HOWARD COUNTY HEALTH DEPARTMENT

RECEIPT DATE: 5/26/20**ONSITE SEWAGE DISPOSAL SYSTEM**P 567398APPROVAL DATE: 14680**PERMIT: MINOR REPAIR**

TRENCHES: <u>EXISTING</u>	LINEAR FEET REQUIRED:	INLET DEPTH:
	TRENCH WIDTH:	MAXIMUM BOTTOM DEPTH:
	MINIMUM SPACE BETWEEN TRENCHES:	EFFECTIVE AREA BEGINNING DEPTH:
LOCATION:	TO BE STAKED BY SANITARIAN DURING PRE-CONSTRUCTION INSPECTION.	
NOTES:	<u>SEPTIC TIE IN</u>

From: Williams, Jeffrey
Sent: Tuesday, June 09, 2020 10:13 AM
To: Bricker, Robert
Cc: Wolf, Kevin
Subject: RE: ~~14670~~ Triadelphia Rd Hand Drawing
14680

PLAT - 7496

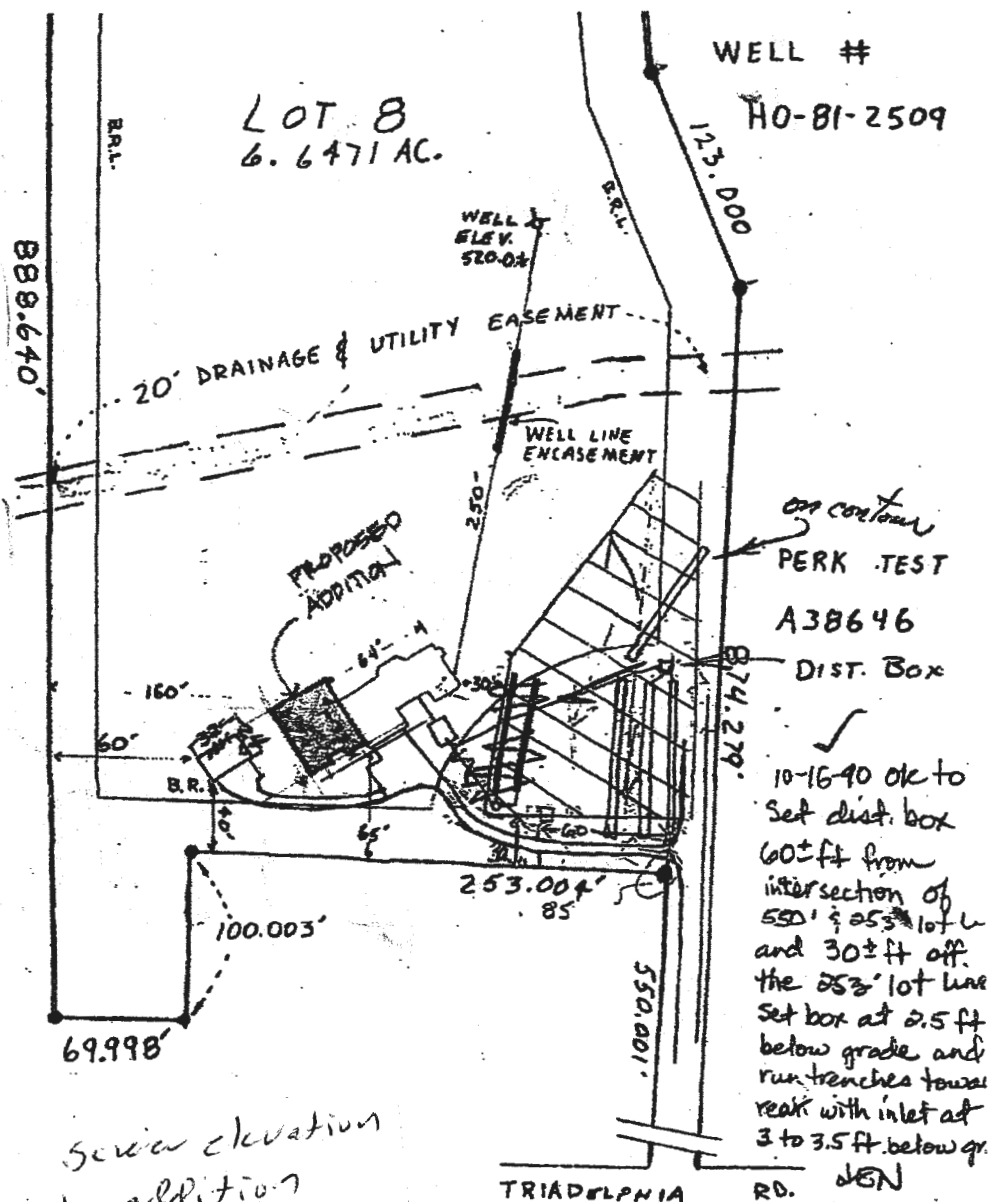
Service elevation
at addition
523.6

PLAT - 7496

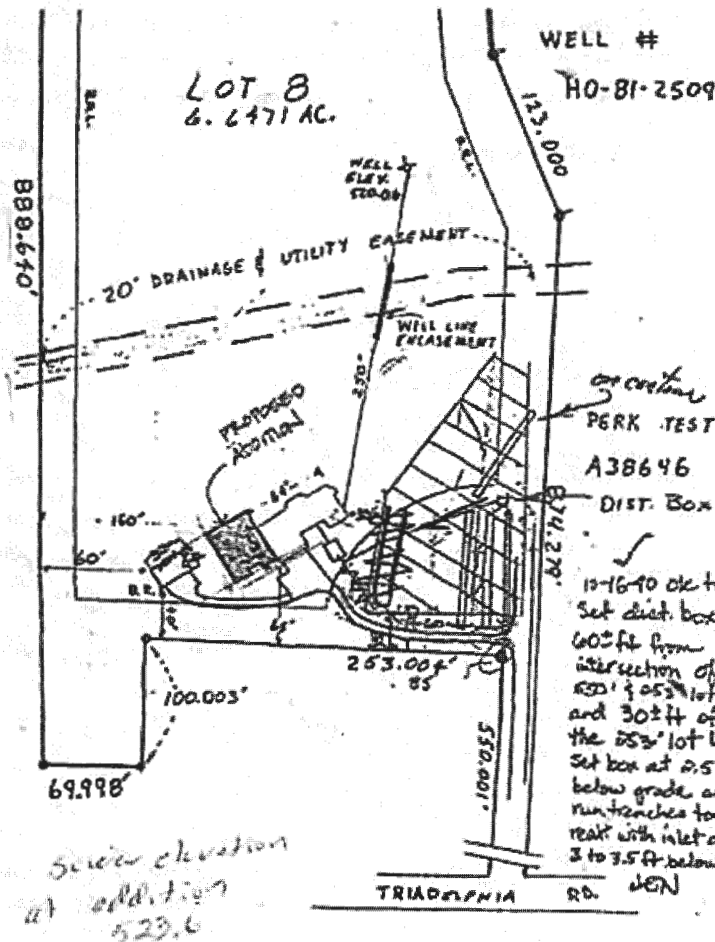
We just need the proper info for the job on the plot plan. If you take the info you gave me on the last submission and add in the proposed sleeve location and material. If you are planning to raise the invert

out of the addition to make 2% fall, just put on there what elevation you propose (if the tank invert is at 523.1 and the run is 60', then the invert out of the house must be at 524.3 or higher. The rest looks fine.

Hello Mr. Runk. We tried to call you last week and could not leave a message. Your drawing here shows a 1% fall from the addition to the invert at the tank. But, you're connecting upstream of the tank, which puts it even shallower. How did you get those elevations and is line leaving the addition already in place?

A 1% fall is acceptable, but not recommended, especially if the real conditions are off by an inch or two, then there is no fall at all.

Also, what is your plan for the sleeve as we discussed and I mentioned in my previous email? Thanks
Jeff

We got the elevations from the plot plan . I thought I sent you a copy of it but I can resend it . We have plenty of grade to run it at 2% so we will change that . We discussed using 6" pvc sleeve under the driveway which we still plan on doing . We have not installed the pipe leaving the addition yet so changing to 2% will not be a problem . If you need anything else please advise as we are getting to the point of holding the job up .
